TRANSMITTAL OF DEFENSE NUCLEAR FACILITIES SAFETY BOARD (DNFSB)  
RECOMMENDATION 2010-2 IMPLEMENTATION PLAN (IP) DELIVERABLE 5.1.3.14.

VESSEL CONFIGURATIONS FOR  
LARGE SCALE INTEGRATED TESTING  
24590-WTP-RPT-ENG-12-017, REV. 0, DATED 04/26/12

# Vessel Configurations For Large Scale Integrated Testing

LSIMS ERT DOCUMENT REVIEW RECORD			REVIEW NUMBER:	ERT-15 Vessel Configuration
			DOCUMENT NUMBER:	24590-WTP-RPT-ENG-12-017, Rev A
			DOCUMENT TITLE:	Vessel Configurations for Large Scale Integrated Testing
6	LMP	O	There seems to be something missing at the end of Section 3.1.2, a “therefore...” Perhaps it is “Hence, testing should include these ranges of solids concentration and rheology.”	Added sentence to clarify, “These ranges need to be considered in developing tests for vessel configurations that process these non-Newtonian fluids.”
7	LMP	O	The criteria in Section 4.1 help frame selection well. Are they weighted in any way? That is not stated when they are introduced, but later (on page 29) there is some indication that they are.	The was updated to reiterate that Criteria 1) and 2) were given greater weight in the evaluation and selection of test arrays.
8	LMP	E	It’s not clear

**Figure 2 Volumetric Scale Ratios of WTP Mixing Vessels Relative to a 14-Foot Diameter Industrial Scale Test Vessel**

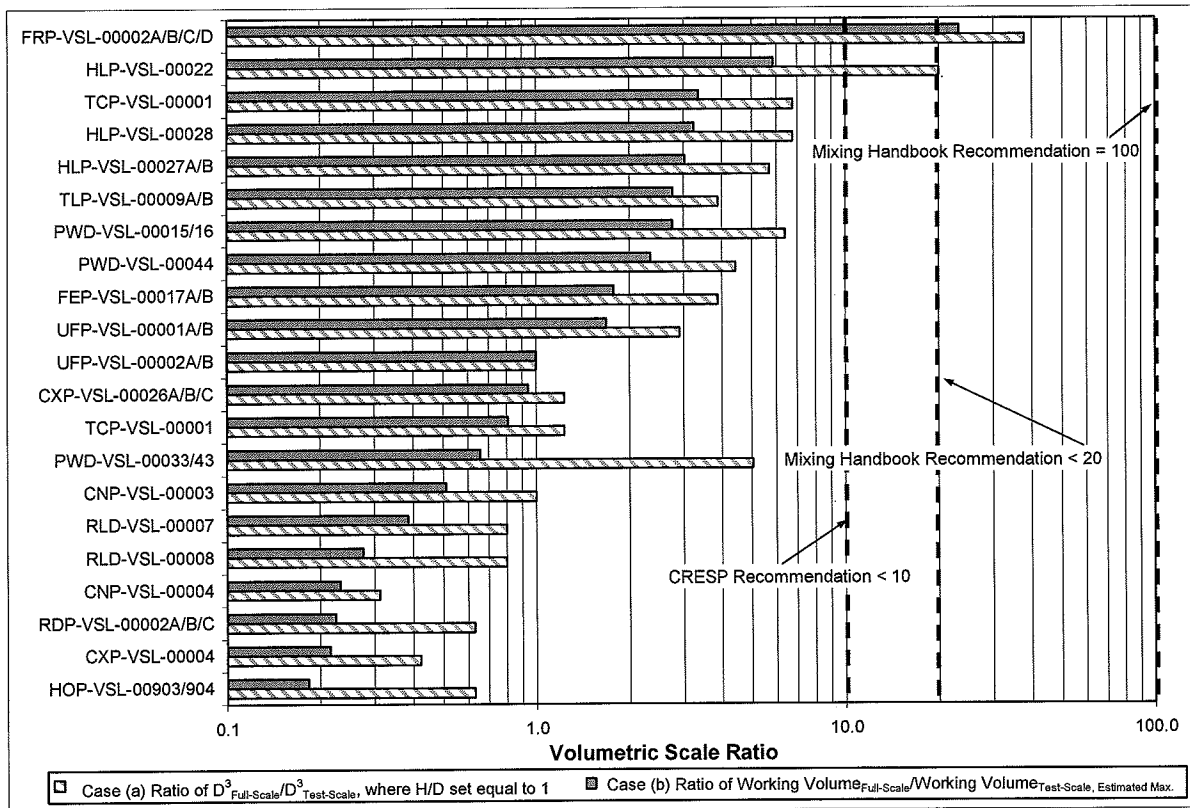
LSIMS ERT DOCUMENT REVIEW RECORD			REVIEW NUMBER:	ERT-15 Vessel Configuration
			DOCUMENT NUMBER:	24590-WTP-RPT-ENG-12-017, Rev A
			DOCUMENT TITLE:	Vessel Configurations for Large Scale Integrated Testing
28	EKH	E	I do like Figure 2; don't get rid of it, since it says a lot. You could use a legend and provide a color code scheme that would show which of the tanks had undissolved solids and their maximum concentration.	Figure 2 was annotated to distinguish vessel type (by range of solids and by vessels that process Newtonian versus non-Newtonian process wastes).
29	EKH	E	Page 14, second paragraph. Yield should be stress.	This was reworded as requested.
30	EKH	E	Page 14, Section 3.1.1. How does the "particulate" settling rate affect shear strength? Settling rate (all regions of settling, free, hinder, and compaction) will affect the height of the settled bed.	This sentence was reworded to explain it applies when the mixers are not operating. The sentence now reads, "The depth and shear strength of a settled layer that may form during periods where mixers are not operating are functions of the waste properties, primarily the undissolved solids content and the particulate settling rate."

Figure 6 Chandelier Array Vessel Design Operating Parameters<sup>(a)</sup>

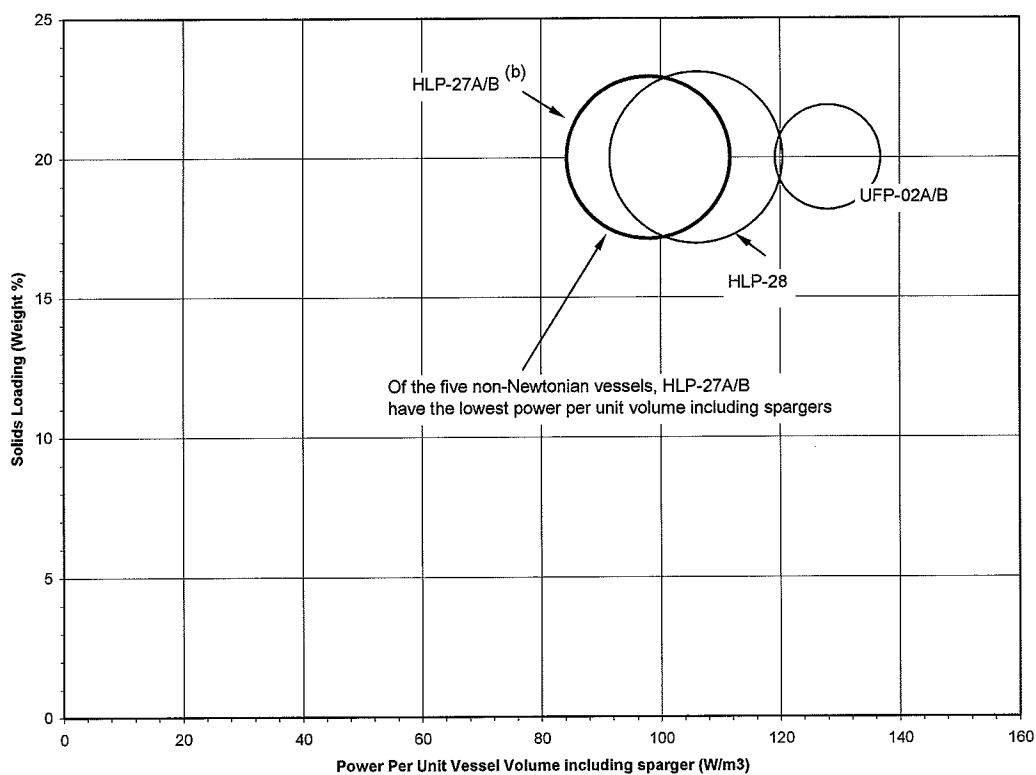
9	LMP	O	There seems to be a logic flow lapse in Section 4.3 in how the “Group” concept translates into Figure 6. Or maybe it’s not supposed to translate, but then it’s not clear why these particular vessels are in Figure 6.	The division of Figure 6 and 7 was clarified in the Section 4.3 text.
10	LMP	M	Once you’ve identified two vessel configurations in Section 4.3, you stop. Criterion 6 is “at least two”, not “two”. Criteria 4 and 5 aren’t well satisfied by the two selected and seem to suggest the need for an 8-PJM array as a third configuration. However, it’s not clear that there are any vessels with 8-PJM arrays that really warrant testing per criteria 2 and 3. But if that’s the case, the document needs to say why you stopped.	This was updated (in particular in Table 9) to indicate that 8-PJM array was reviewed but not selected as the vessels where an 8-PJM array is applicable do not meet Criteria 1) and 2).

98	RRH	M	Page 24, Figure 5. Circles imply that PJM provides a circular clearing region. This is not true with chandelier array.	A footnote was added to clarify that actual area is not circular, but is depicted as a circle for ease in comparison.
99	RRH	E	Page 26, Table 11. Some of the numbers in the column for Area coverage/PJM appear to be incorrect, e.g., Group 2 7.3 should be 3.57, Group 3 should be 2.39 to 2.74, Group 4 5.7 should be 6.4, Group 5 should be 2.4 to 13.4, Group 6 should be 5.85. Please check these numbers with your calculations.	Thank you. The table was updated. It is now Table 8 in the current document.
100	RRH	O	Page 29, second paragraph. Challenge of 30	The text was changed in footnote to

Note (a) Please note that the clearing region provided by a PJM in a chandelier array is not circular, but is shown as circles in this figure for the purpose of vessel-to-vessel comparison.  
 (b) To improve visibility in Figure 6, the coverage area per PJM for HLP-VLS-00027A/B is shaded in blue.

**Figure 8 No Solids Distributed Array Vessel Design Operating Parameters**

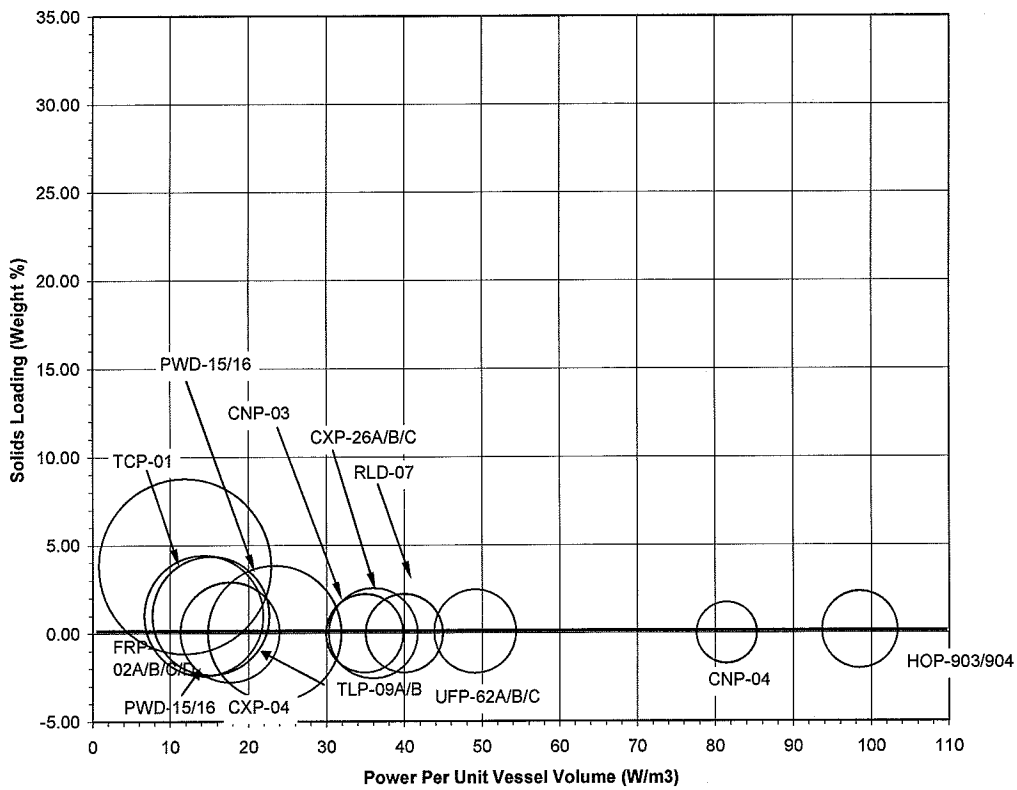
40	EKH	E	Figure 7. What is the first circle (vessel) in this figure? It does not have a zero solids loading. Should it be here or on Figure 6?	Note added to clarify why FRP-VSL-00002A/B/C/D is included in Figure 7.

Note: FRP-VSL-00002 A/B/C/D is grouped with the low/no solids vessels in Figure 8, because the solids in this vessel are very slow settling.
